Minor Variance Items #1, #2 & 5(a)-5(d) This Sheet / Schedule F of Application

COMMISSION TITLE:
**PROPOSED
MIXED-USE
DEVELOPMENT**

6289 FALLSVIEW BOULEVARD
NIAGARA FALLS, ONTARIO

SHEET TITLE:
SITE PLAN

1 SITE PLAN A1.0 1:400

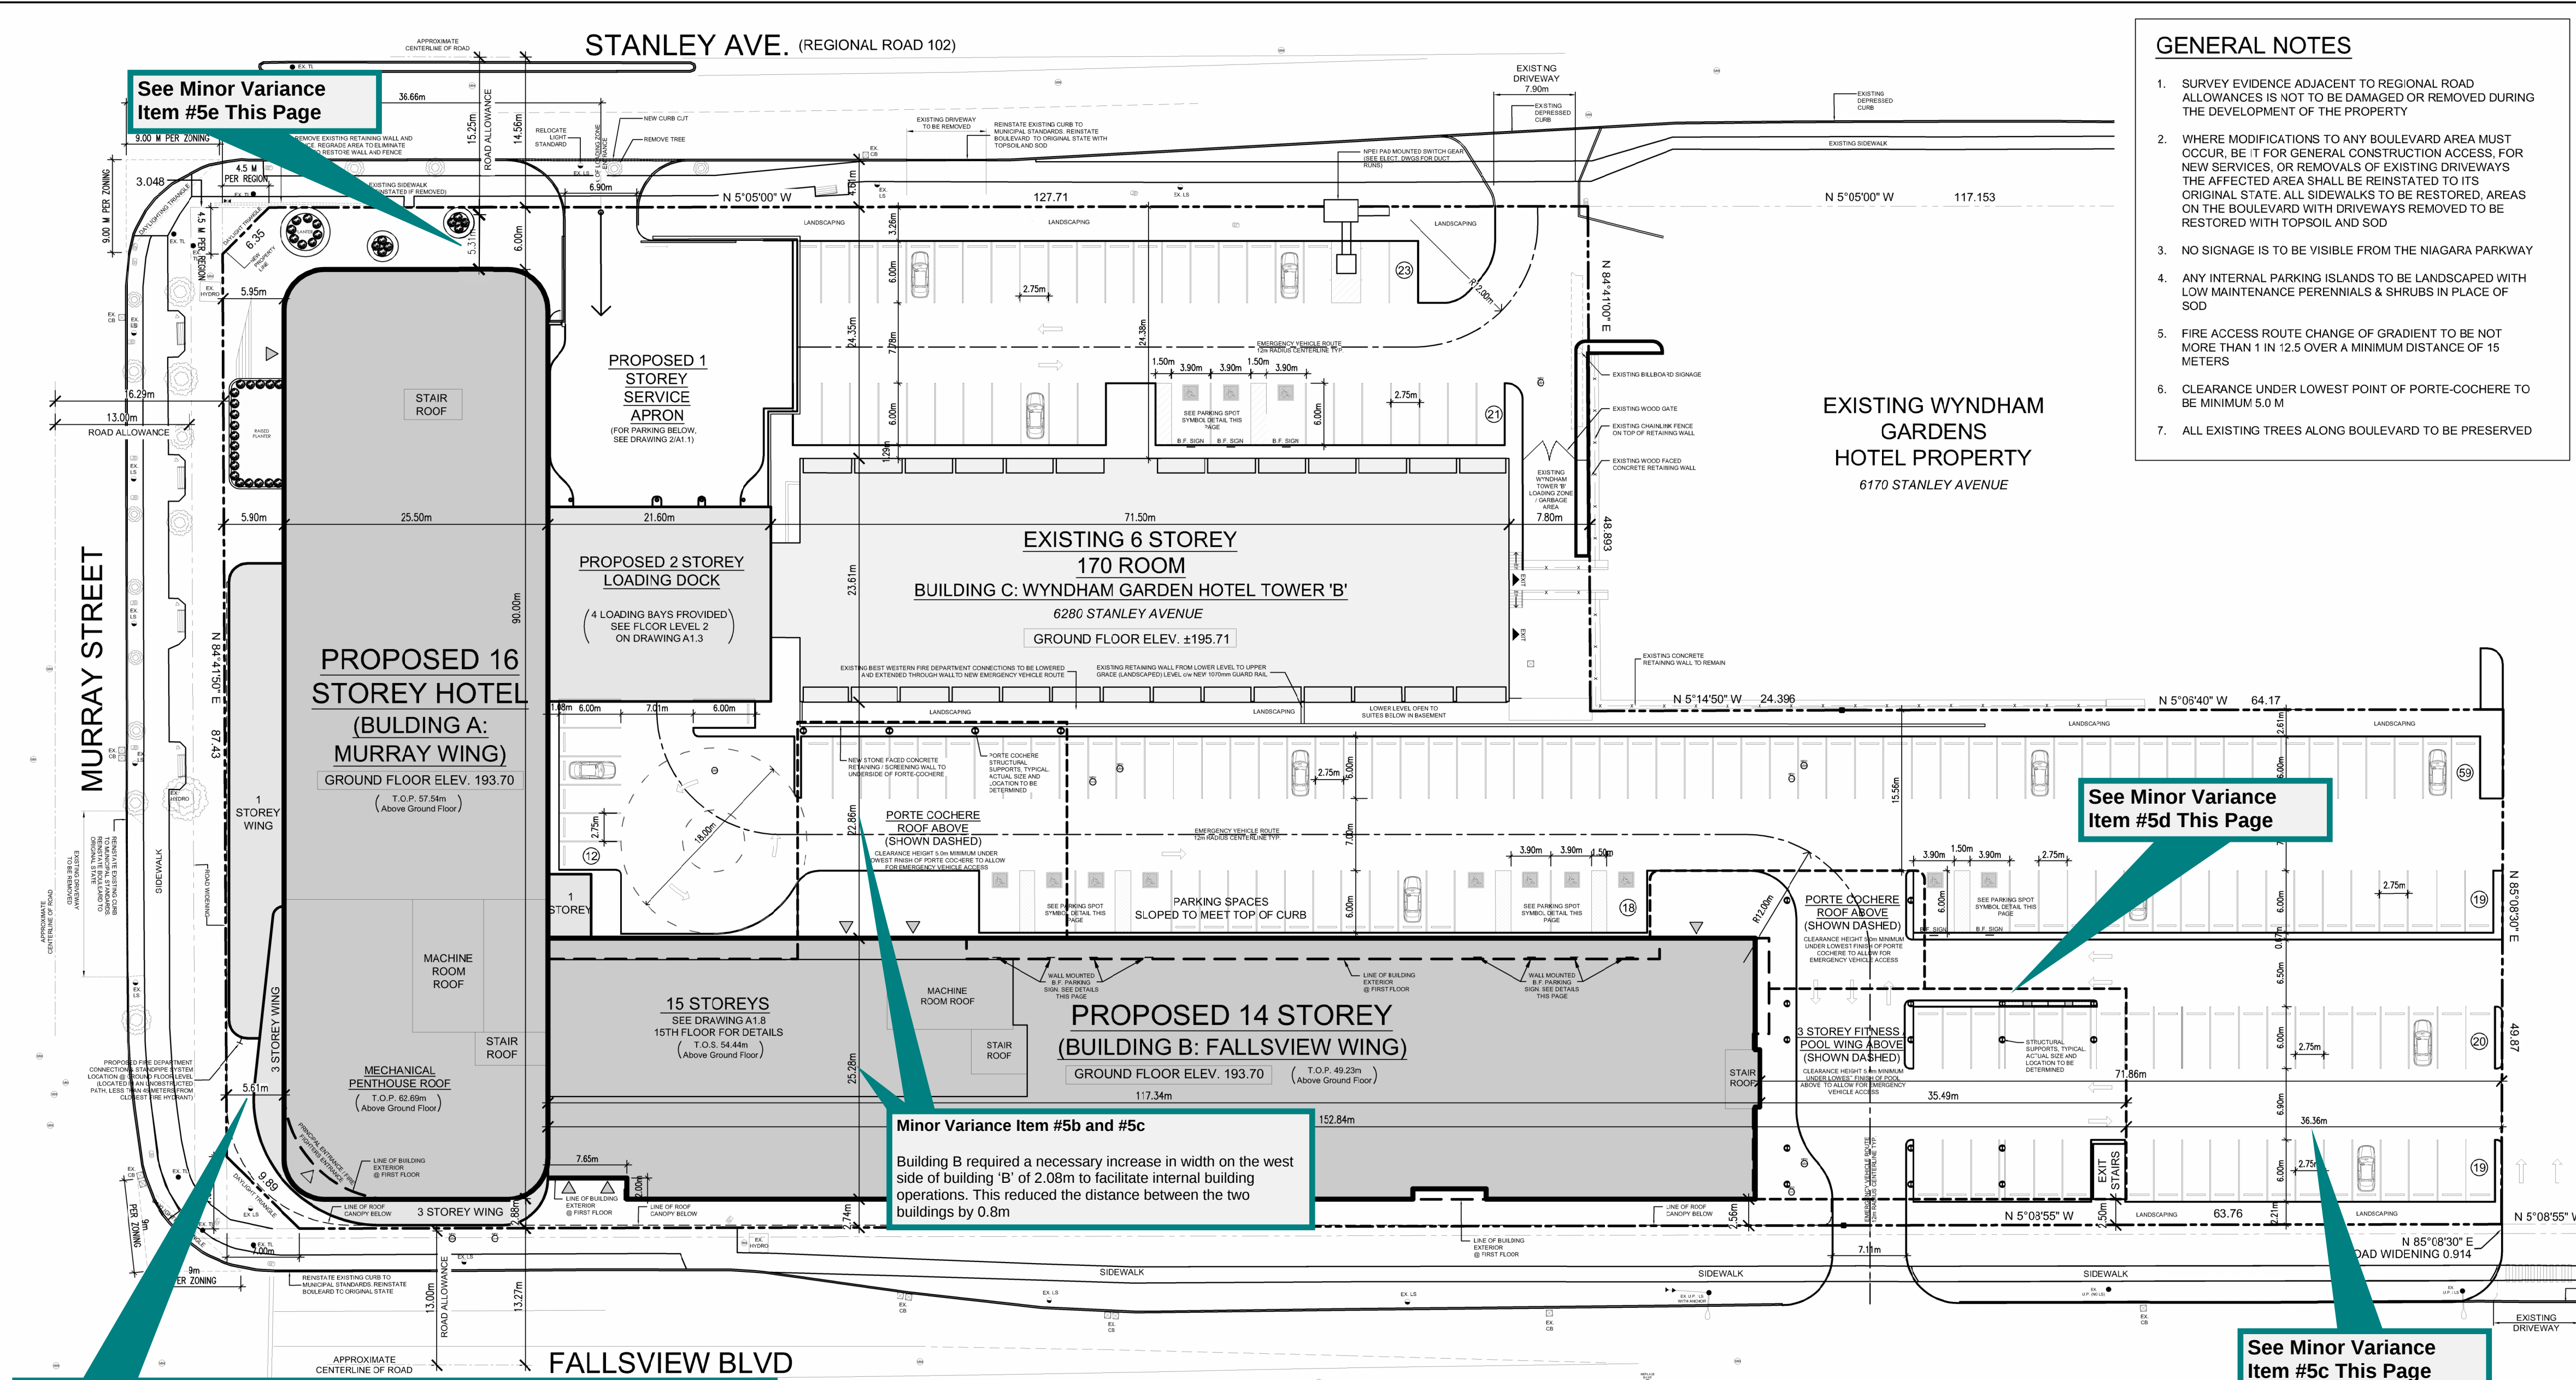
Item #1: Requirements under zoning by-law 79-200 Section 8.6.1.(ii):

Dwelling units in a building in combination with one or more of the uses in this section (hotel use). Not more than 50% of the total floor area in a mixed-use building is used for dwelling units and further provided that such dwelling units except entrances thereto are located entirely above the ground floor

Item #2: Requirements under zoning by-law 79-200 Section 14.9 Table 1:

We require a total of 578 parking spaces (on-site and off-site combined)

Dwelling containing 3 or more dwelling units save and except an on street townhouse dwelling requires 1.4 parking spaces for each dwelling unit.

For the 144 dwelling units being provided we are required to use 202 parking spaces for residential parking of the 213 available on-site

Items 5(a) to 5(c) represent changes to dimensions based on schedule 3 of by-law 2020-045. Items 5(a) and 5(c), as indicated by the city, are representative of distances set from the property line to the upper portion of the building above 12m as shown on schedule 3 of by-law 2020-045.

Item 5(d) represents an increase in permitted height for a portion of the building over the 12m permitted by by-law 2020-045 6(c)(iv). See East Elevation Drawing A3.3 for height dimension of Building 'B' extension (pool/fitness amenity)

Item 5(e) The zoning department has indicated that the 5.8m setback to the upper portion of the building (anything over 12m) as shown on schedule 3 of by-law 2020-045 is not to be taken from the property line, but from the road allowance line which extends +/- 0.63m over the property line. With the building being 6m away from the property line, this has reduced the 5.8m dimension shown on schedule 3 of by-law 2020-045 to a dimension of 5.31m to the upper portion of the building

Minor Variance Item #5a

The plans for our proposed building have consistently mentioned a distance of 5.9 meters from the Murray Street property line to the main tower (Building 'A'), near the southwest corner. However, there was an oversight in aligning the building on previous approved submissions (site plan agreement, rezoning, building permits), leading to the mistaken belief that this distance remains consistent along the entire length of the south face. In reality, the building is off-axis along the Murray Street property line, making us 300mm closer to the property line near the southeast corner. Since a significant portion of the foundations have already been constructed to support the upper building, we request a minor variance to permit the reduction in distance from the property line and allow the upper portion of the building to remain as shown on the drawings.

Proposed Changes For Item #1

70% total floor area allowed for dwelling units in a mixed-use building
30% total floor area allowed for hotel use
Floor areas of common areas to be split 50/50 between dwelling unit total floor area and hotel total floor area

Transitioning to a 70% / 30% floor area allocation for dwelling units / hotel units makes better financial feasibility rather than 50% / 50%

Proposed Changes For Minor Variance Item #2

We request that the by-law requirement of 1.4 parking spaces for each dwelling unit be lowered to 1.25 parking spaces for each dwelling unit.

We would then require a total of 556 spaces be provided (on-site + off-site combined), a difference of 22 spaces, and:

The site offers a restricted amount of on-site parking availability. Without any relief from zoning requirements, all but a few on-site parking spaces would be designated solely for residential use, including accessible parking. By providing relief, thirty-three (33) additional parking spaces can be allocated toward the hotel use, including access to accessible parking spaces. This is in line with current Niagara Falls parking trends.
